08-2018 LATEST REVISION DATE APPROVED BY BRIDGE ENGINEER	 STANDARD DESIGN - 40' ROADWAY, 3 SPAN BRIDGES ROLLED STEEL BEAM BRIDGES JUNE, 2010
	PIER BEARING DETAILS 280'-0 TO 340'-0 SPAN
	RS40-095-10

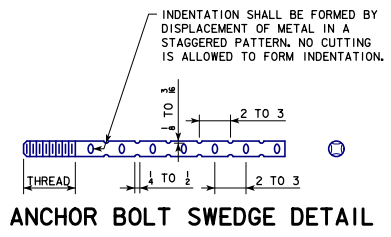
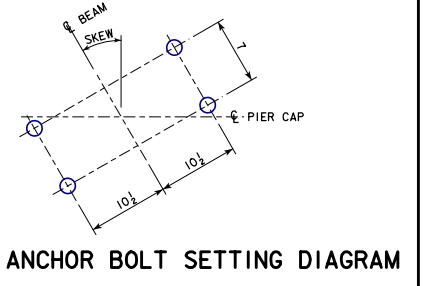
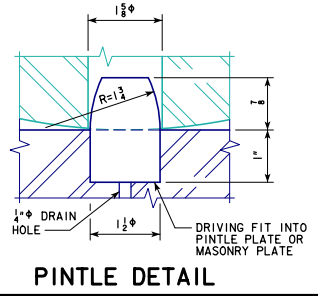
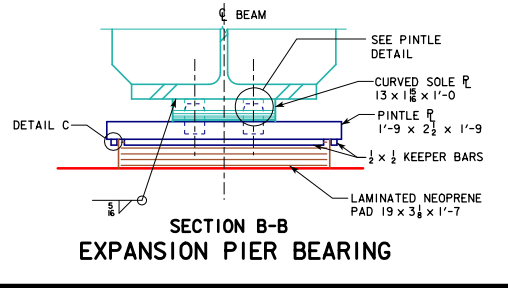
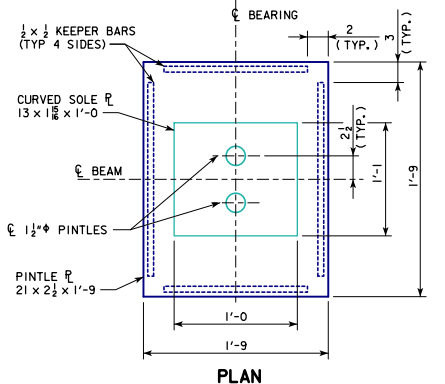
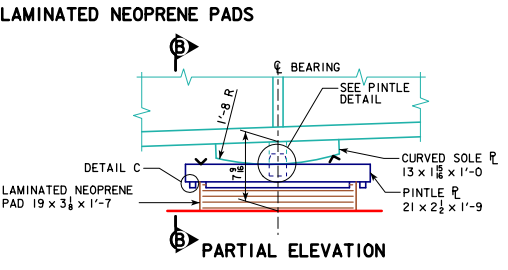
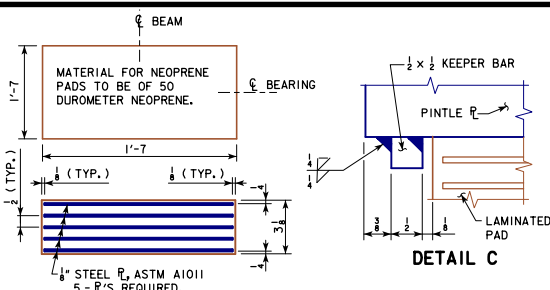
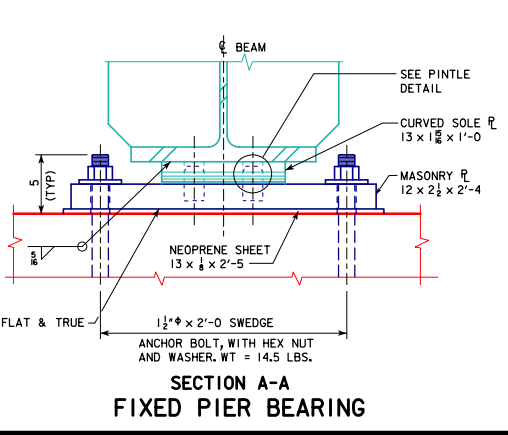
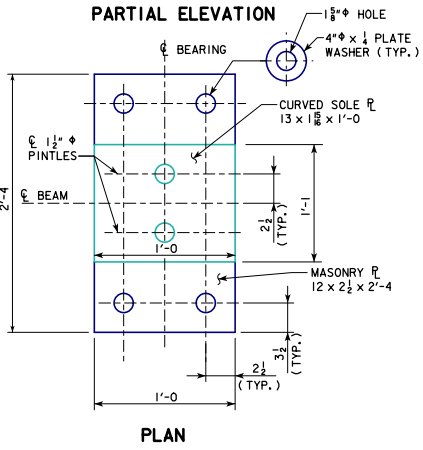
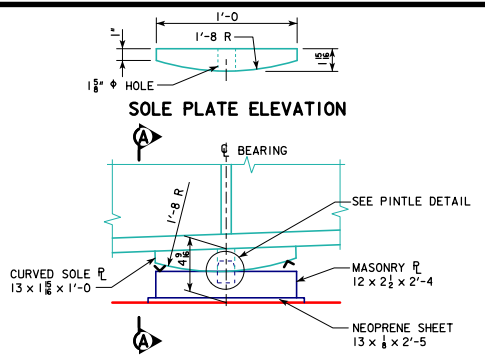
REVISED 08-2018 - CHANGED FIXED PIER BEARING ASSEMBLY THICKNESS IN "PARTIAL ELEVATION" DETAIL TO 4 1/8" (WAS 4 1/4"). UPDATED BRIDGE ENGINEER SIGNATURE.
